**RE: Regional Centre MPS Amendment and Substantive DA Amendment Opal Ridge (Penhorn) Special Planning Area**

Regional Centre MPS - Proposed Map 11 Revisions

Figure 2 Proposed Map 11

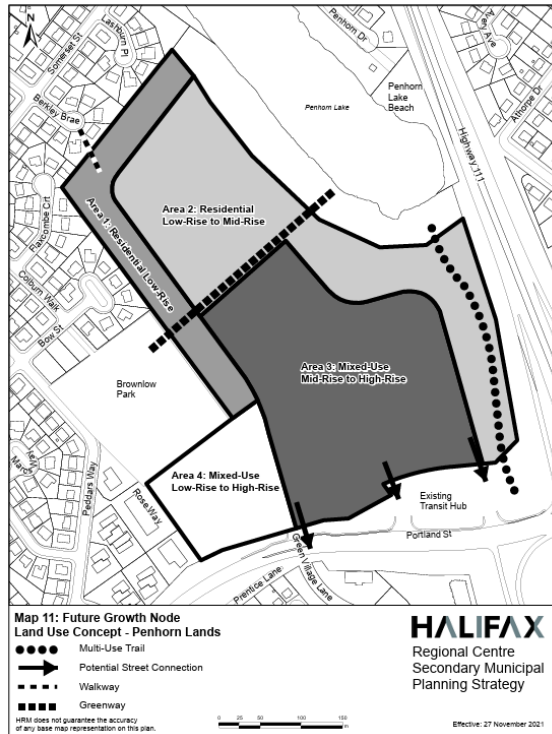
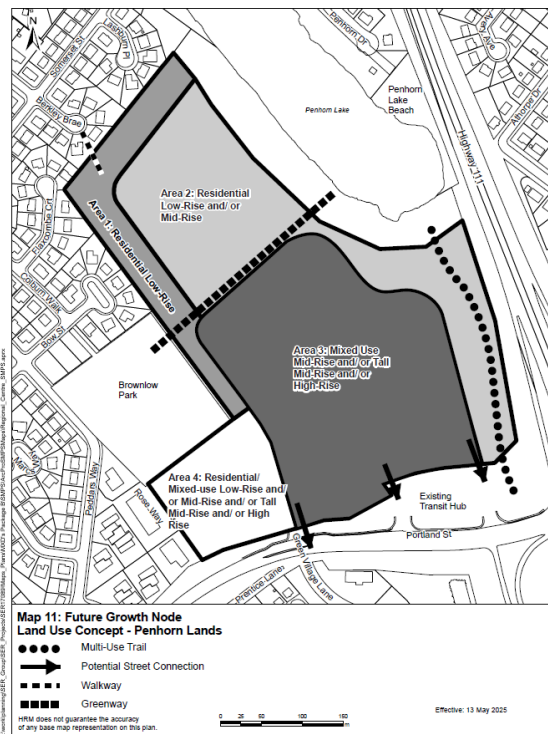
A number of housekeeping updates are requested to the Future Growth Node Land Use Concept (Map 11 of the Regional Centre MPS) which reflect experience working with the policy and the above changes:

- Area 1/Area 3: A minor adjustment to the line between area 1 and 3 will allow for logical building form for Block B rather than having to split a building into low rise and mid-rise forms, a very awkward situation. Original policy for this area made several assumptions including that road locations would enable low density housing on the western side of the site adjacent Brownlow Park. This assumption did not take place and this area has mostly been used as a road, multi-use path and street trees. This separation from Brownlow Park has a similar affect to the transitions originally anticipated so buildings loom over the park. The location of Area 3 can now be adjusted to the edge of the right-of-way for Opal Ridge Drive. Further, Area 3 should be expanded to include the entirety of Block A.

- Area 2 through 4: Labelling for building types should be clarified to appropriately identify available options and reflect clarifications related to building form requested above.
